PLANNING REPORT

Planning & Zoning Commission

Block H – Bridge Park
SITE PLAN REVIEW

Agenda Item	3
Case Number	17-055 SPR
Proposal	A Site Plan Review for the construction of a residential condominium development consisting of 64 townhome units. The site is located within the Bridge Street Scioto River Neighborhood District on the west side of Dale Drive, south of the intersection with John Shields Parkway.
Request	Review and a recommendation of approval to the Planning and Zoning Commission for a Site Plan Review and Waiver Review under the provisions of Zoning Code Section 153.066.
Site Location	Located on the west side of Dale Drive, south of the intersection with John Shields Parkway.
Applicant	Crawford-Hoying; represented by James Peltier, EMH&T
Case Manager	Lori Burchett, AICP Planner II (614) 410-4656 lburchett@dublin.oh.us
Planning Recommendation	Approval The proposed Administrative Departures, Waiver Reviews, and Site Plan Review is consistent with previously approved development plans and meets all the applicable review criteria and approval is recommended. Approval of the 18 Waiver Reviews is also recommended. Administrative Departures (approved by ART on July 6, 2017)

ARCHITECTURAL SITE PLAN

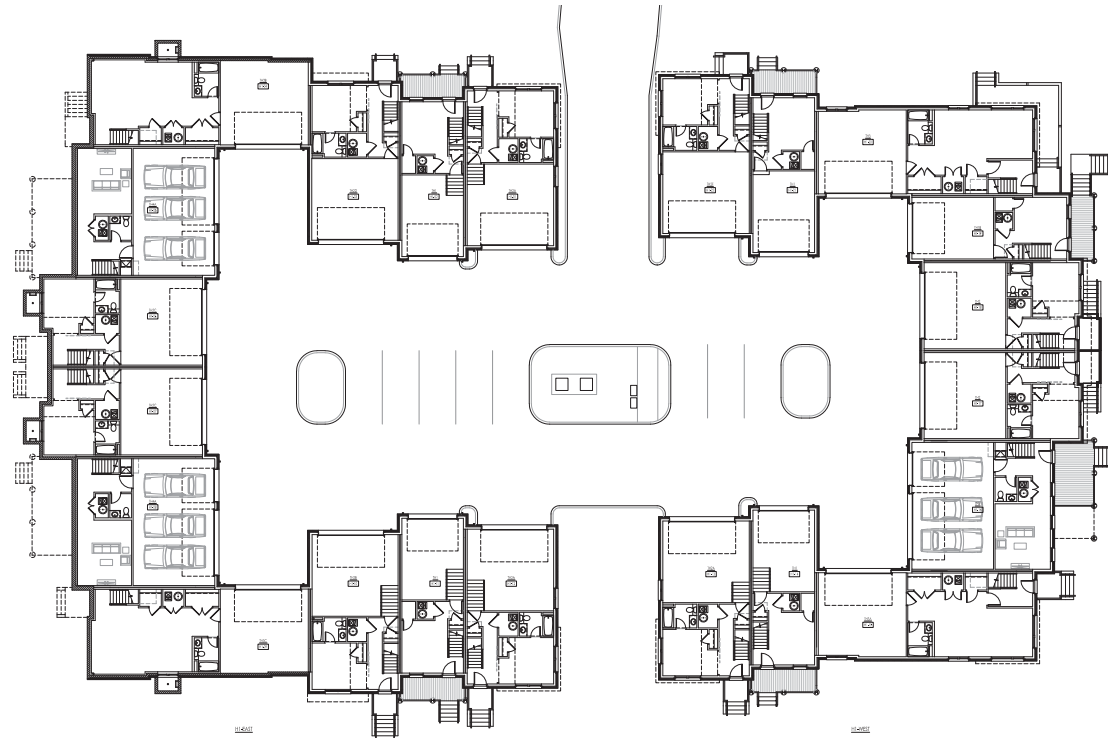
- 1) That the applicant define a portion of the courtyard as Public Open Space in order to comply with the Open Space Node shown on Figure 153.063—Neighborhood Standards (6)(d)(2)—Open Space Network.
- 2) That the applicant be required to submit construction details for the surface parking lot to the satisfaction of staff, prior to building permit approval.
- 3) That the applicant remove the off-street parking spaces from the parking count on the site plan.

(3)(d)	Outdoor Waste and Storage Containers and Enclosures	The Site Plan does not indicate any areas for Outdoor Waste Storage Containers and Enclosures.

ART Recommendation	Site Plan Review
Conditions	<p>1) Define a portion of the courtyard as Public Open Space in order to comply with the Open Space Node shown on Figure 153.063—Neighborhood Standards (6)(d)(2)—Open Space Network.</p> <p>2) The applicant will submit construction details for the surface parking lot to the satisfaction of staff, prior to building permit approval.</p> <p>3) The applicant will remove the off-street parking spaces from the parking count on the site plan.</p>

B U I L D I N G H 1 E M O T O R C O U R T S O U T H E L E V A T I O N

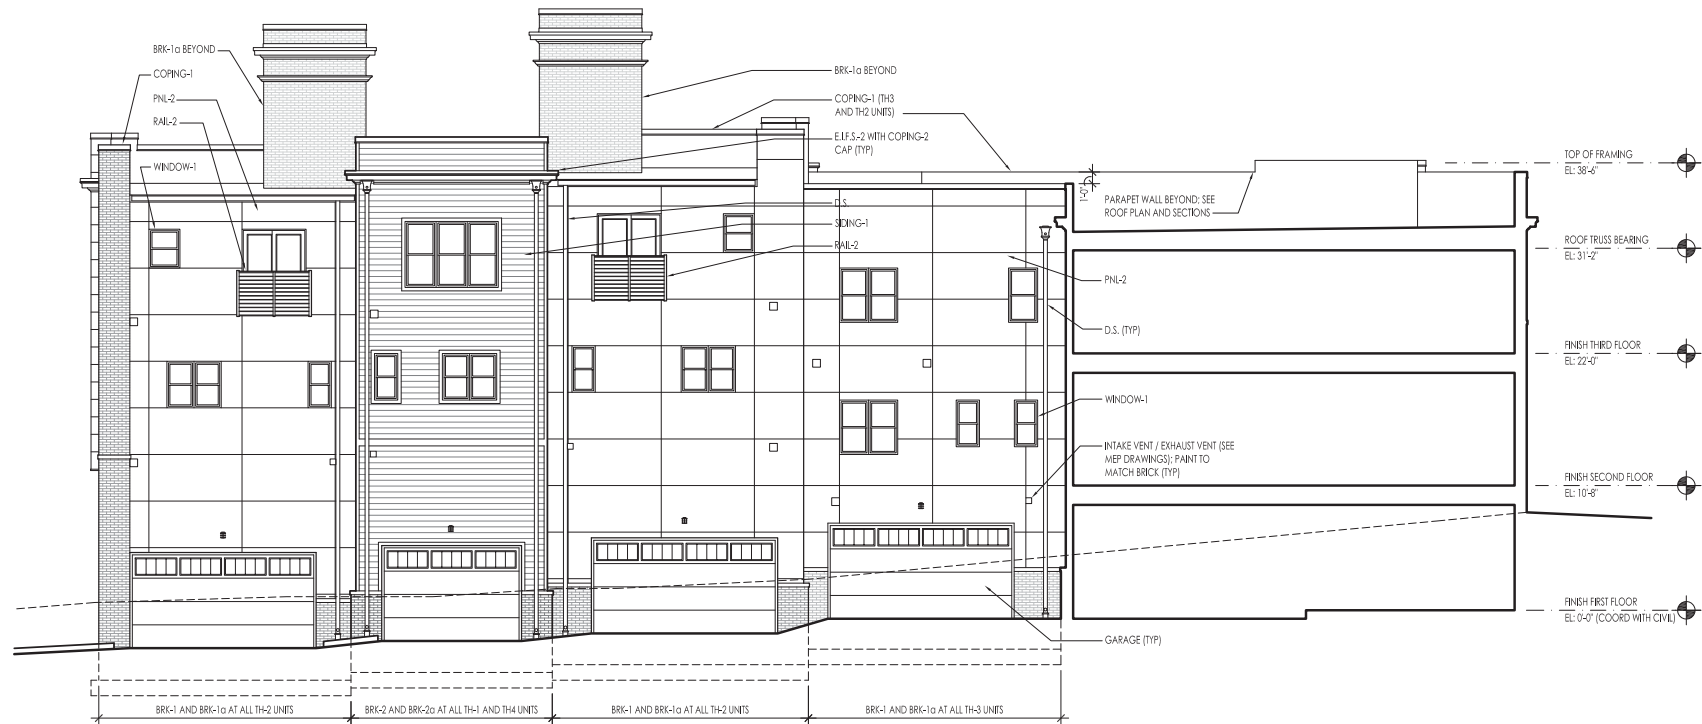
Waiver Review		Site Plan Review
	<p>12%; 1st Floor Motor Court South: 7%; 2nd Floor Motor Court South:14%; All Floors Motor Court East: 0% (H1 East and repeated elevations)</p> <p>1st Floor Passage West: 9%; 1st Floor Motor Court West: 10%; 2nd Floor Motor Court West: 12%; 1st Floor Motor Court North: 8%; 2nd Floor Motor Court North: 12%; 1st Floor Motor Court South: 7%; 2nd Floor Motor Court South: 14%; All Floors Motor Court East: 0% (H2 East and repeated elevations).</p> <p>1st Floor Passage East: 10%; 3rd Floor Passage East: 13%; 1st Floor Motor Court East: 7%; 2nd Floor Motor Court East: 11%; 3rd Floor Motor Court East: 12%; 1st Floor Motor Court North: 7%; 2nd Floor Motor Court North: 11%; 3rd Floor Motor Court North: 12%; 1st Floor Motor Court South: 7%; 2nd Floor Motor Court South: 11%; 3rd Floor Motor Court South: 12% (H1 West and repeated elevations).</p> <p>1st Floor Passage East: 9%; 1st Floor Motor Court East: 10%; 2nd Floor Motor Court East: 13%; 1st Floor Motor Court North: 8%; 2nd Floor Motor Court North: 13%; 1st Floor Motor Court South: 8%; 2nd Floor Motor Court South: 13%; All Floors Motor Court West: 0% (H2 West and repeated</p>
